**CORRECTIONS FOR EROSION AND SEDIMENT POLLUTION CONTROL PROGRAM MANUAL  
ID 363-2134-008 March 2012**

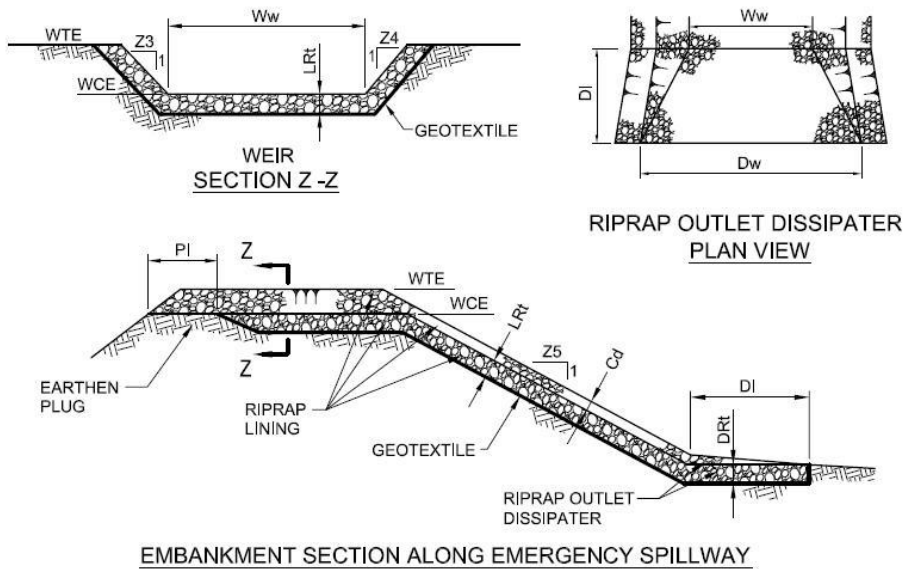
124 Equation for 2-year storm:

$$I = \frac{106}{T_c + 17} = \frac{106}{23.24 + 17} = \frac{106}{40.24} = 2.63 \text{ in/hr}$$

124 Equation for 10-year storm:

$$I = \frac{170}{T_c + 23} = \frac{170}{23.24 + 23} = \frac{170}{46.24} = 3.68 \text{ in/hr}$$

125 Overland Flow Time  $T_{of} = 11.6$  and  $T_c = 23.24$

**STANDARD CONSTRUCTION DETAIL # 7-12  
Sediment Basin Emergency Spillway with Riprap Lining**

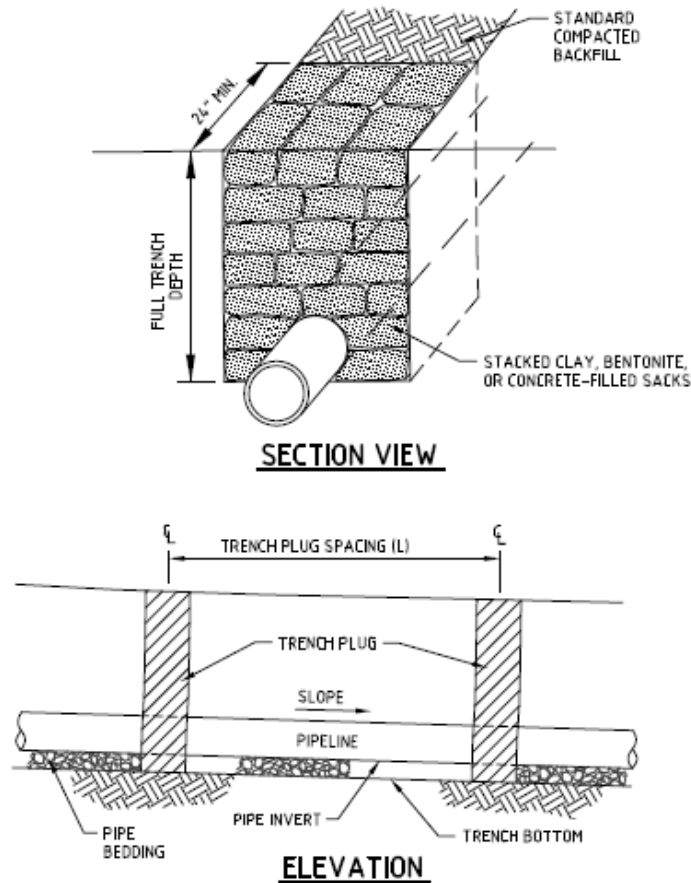
193
